No. 6 DESIGN.—I cannot too highly praise this design. It is one the designer may well be proud of, for it shows a scheme which if carried out—with but one or two very minor alterations—would convert Cathedral Square into by far the most attractive civic centre in the Dominion, and one which would be comparable with the best seen elsewhere.

Elevation, Plan and Details of Messrs. Hart and Reese's Design in recent Competition for Improvements of Cathedral Square, Christchurch.

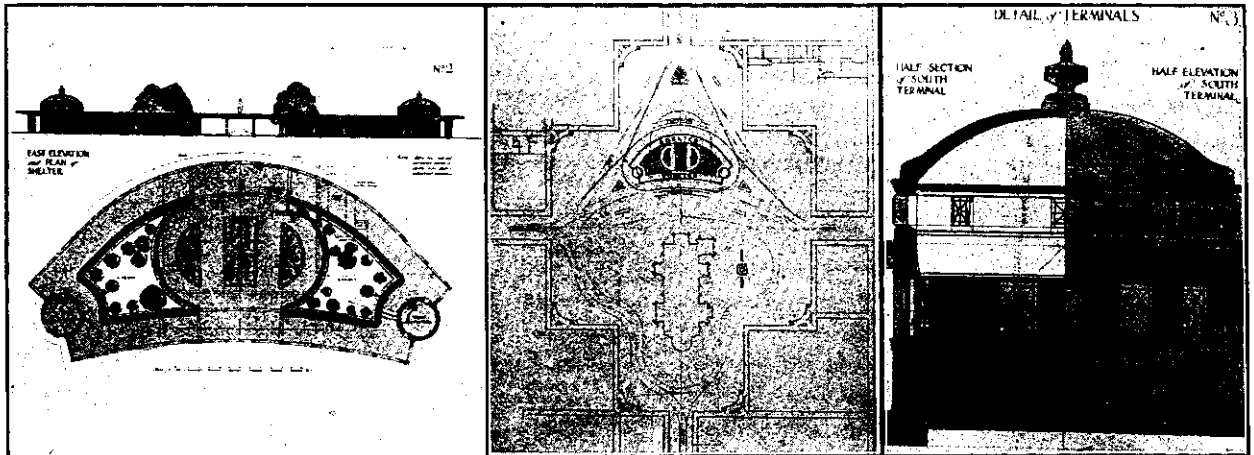
This design and Nos. 7 and 8, adopt the suggestion for north and south shelters in the centre part of the square, but the essential difference between No. 6 and Nos. 7 and 8, is that while Nos. 7 and 8 retain the double line of trams on the eastern side of the shelters with its acknowledged defects, No. 6 separates the lines, leaving the line on which the trams run from north to south in its present position, and removing the south to north lines to the western side of the shelter. By running the present south

The paths through this garden form a most convenient and pleasing connection between the east and west colonnades of the shelters and would thus materially relieve the traffic along them.

This arrangement of lines enables the passengers to enter the cars from the shelter side and to leave by the opposite side—an arrangement which would remove the present most inconvenient and annoying scramble, and would save a very considerable amount of time and expense to the Tramway Board.

This feature has not been noted by the competitor, and he has not provided a footway on the Eastern side, but there is ample room for one 12 ft. wide and still leave a roadway 6 ft. wider than the roadway north and south of it.

It is well suggested that the Godley statue should be moved to the westwards and placed in a curved triangular pavement corresponding to the space formed by the tram lines. The space between the eastern side of this curved pavement and the tram line going north, would form an ideal landing space

to north line to the western side of the shelter, it has been possible to place the shelters further east thus making a very easy curve for the new south to north line. The north and south shelters are connected by a covered colonnade on the east and west sides thus forming with the shelters, a continuous curved shelter of pleasing form. The shelters terminate north and south in circular rooms in which at the north end is the parcel office, and ladies' room and at the south end the ticket office and inspectors' room.

These terminal rooms are covered by raised domes thus giving the required relief and emphasis to the design without clashing in any way with the view of the Cathedral.

The connecting colonnades open on to a central garden space which is formed on the site of the present grass mound. In this the present trees are carefully preserved. This garden is a most convenient and delightful feature of the design as it provides well sheltered seats in what may be formed into a beauty spot—a charming resting and meeting place free from the rush of tram passengers.

for passengers coming from the south, quite free from vehicular traffic.

It will be seen that this design provides for no less than 440 ft. run of colonnade without in any way encroaching upon required traffic space. This would allow for ten trams to stand opposite the colonnades. The details of the design are in excellent taste and the architectural treatment is carried into supporting columns, lamp standards and flower vases which would all increase the aesthetic value of the scheme.

A further consideration of the vehicular traffic problem suggests a somewhat different placing of the "Islands" shown in the scheme. I have therefore prepared a scheme in accordance with this design as a basis which will I think, fulfil the requirements. At present vehicular and pedestrian traffic run riot, a proper system must be accepted and the traffic regulated in accord with it.
